Subject: CPV Vaca Station (08-AFC-11)  
Response to CEC Staff Data Requests 1 through 53

*Application for Certification*  
**Response to CEC Staff  
Data Requests 1 through 53**

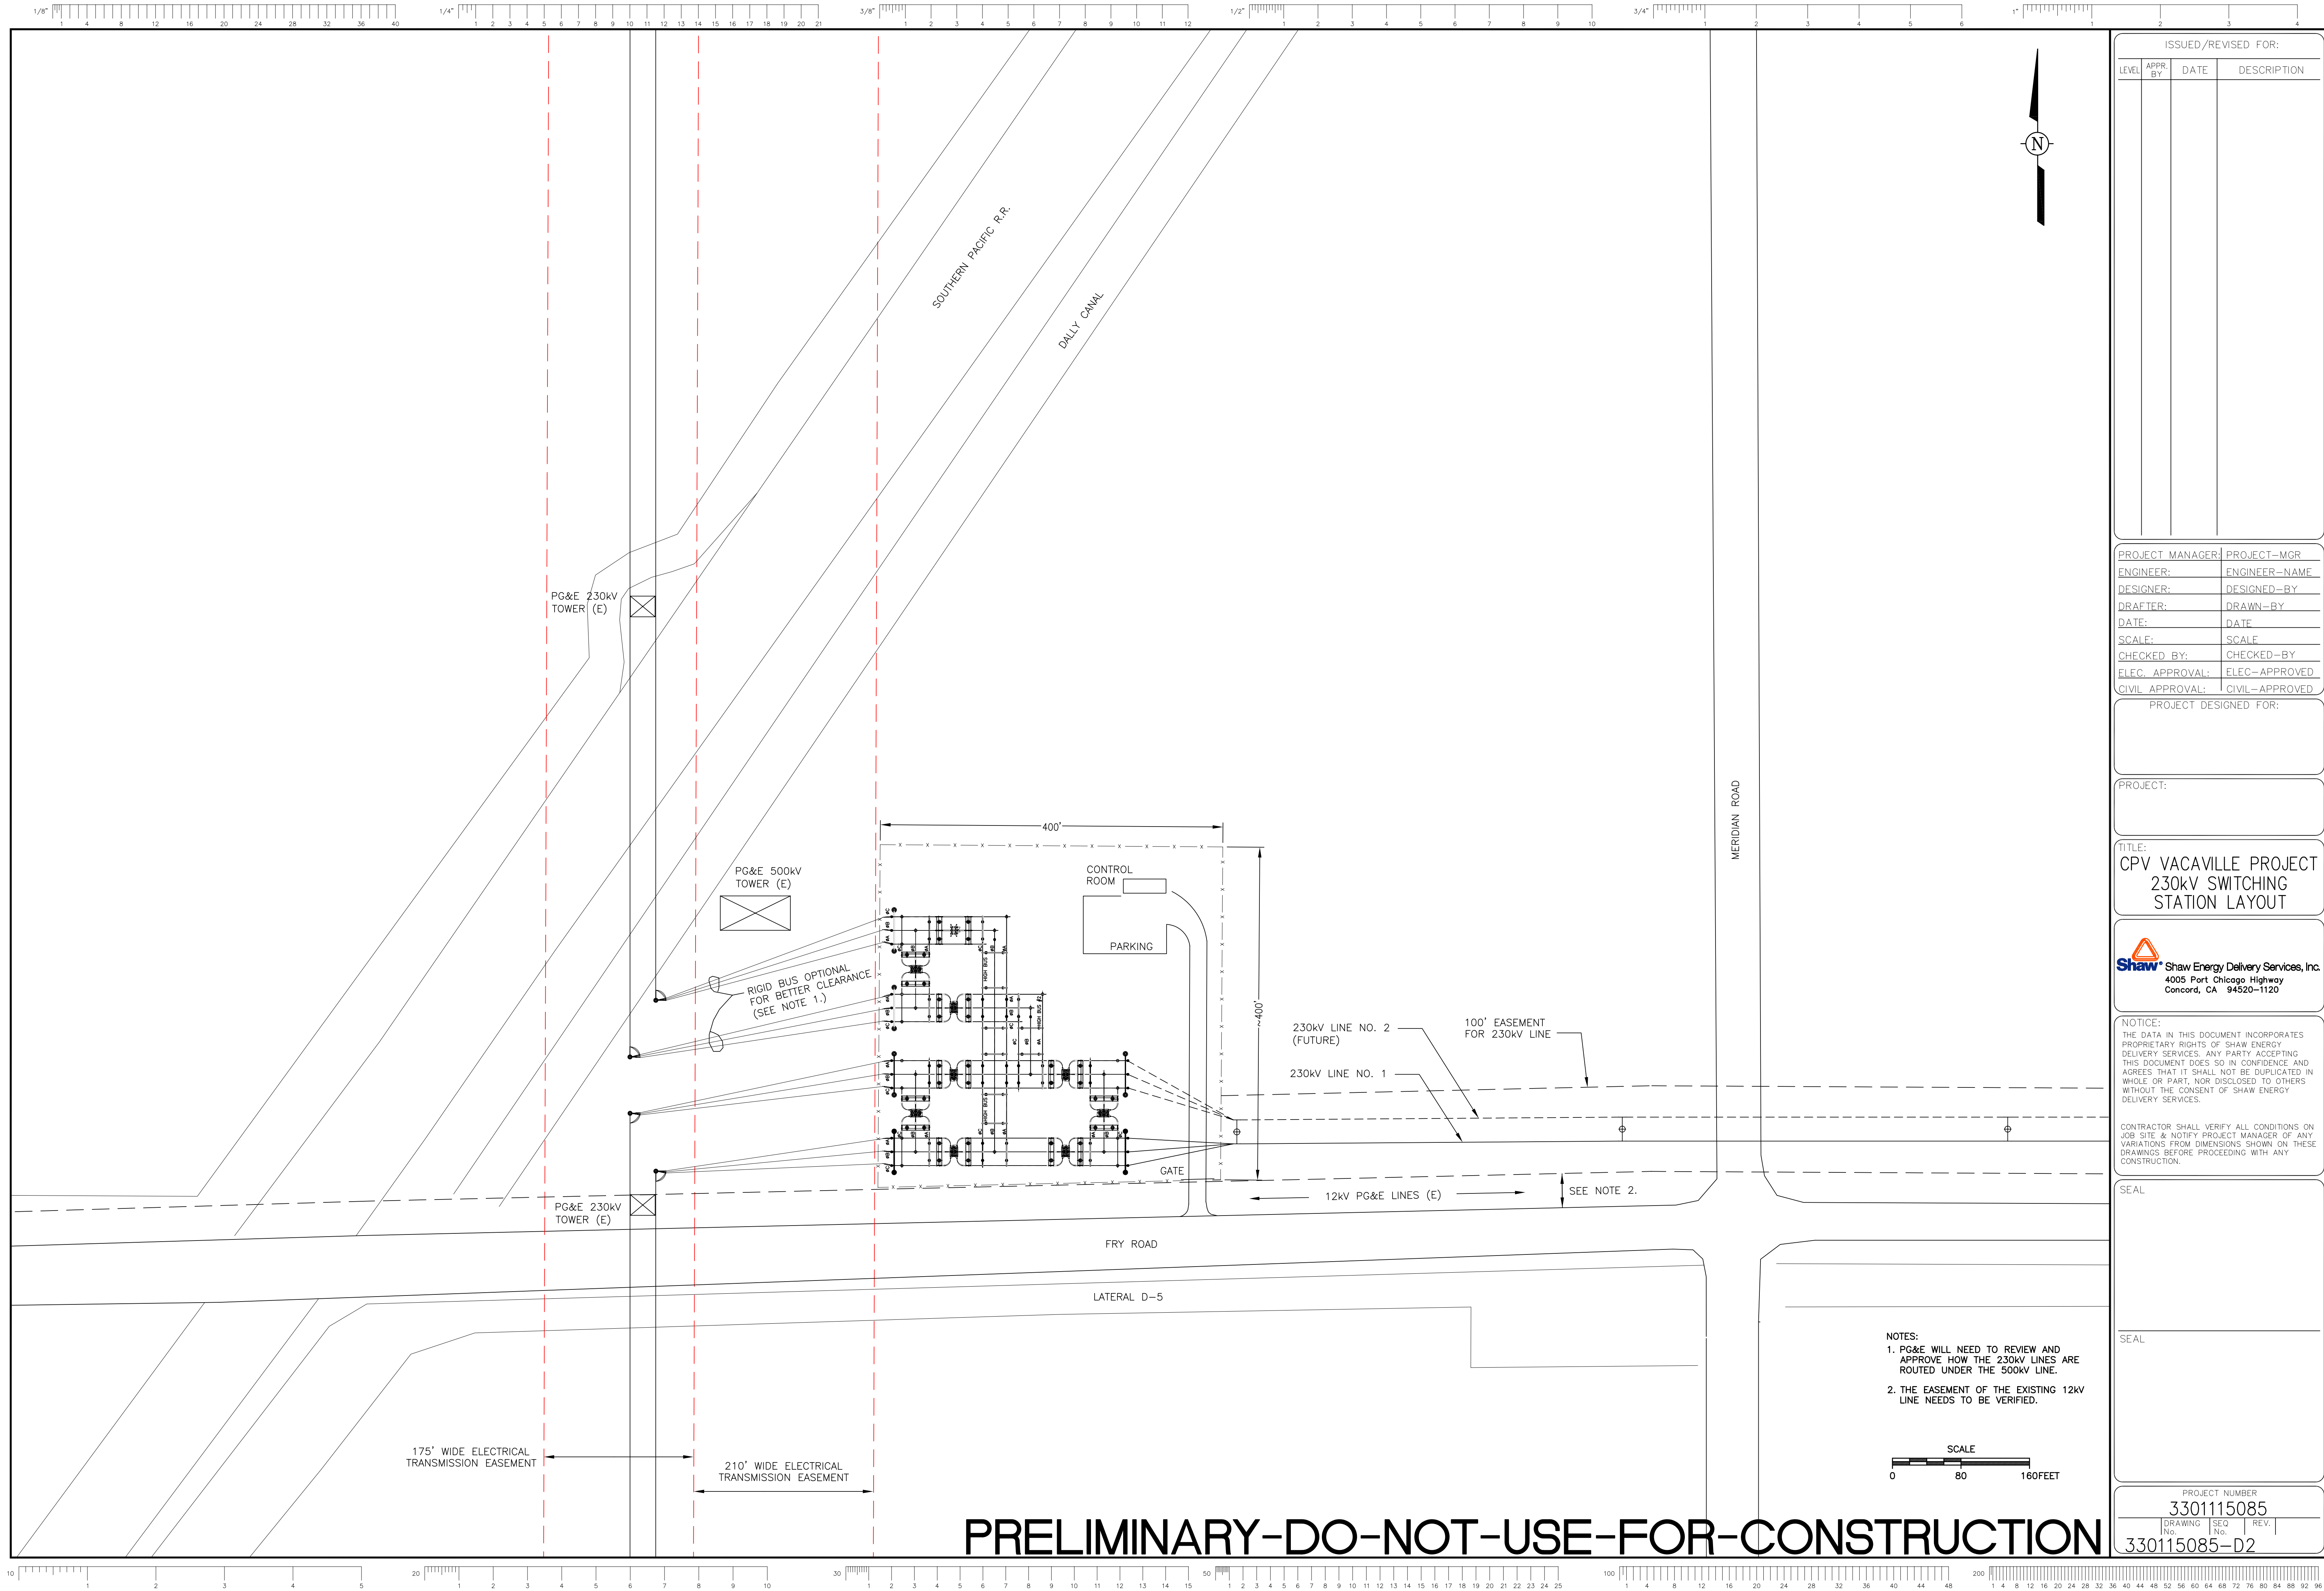
49. *Please provide a scaled layout plan of the interconnection substation showing major components and site boundaries, in relation to Fry Road; and scaled elevation views of the proposed interconnection substation.*

**Response:** Figure DR49-1 is a scaled layout plan of the substation showing major components and site boundaries in relation to Fry Road. The visual simulation (see response to Data Request #50) provides an elevation view based on typical structure heights for this equipment.
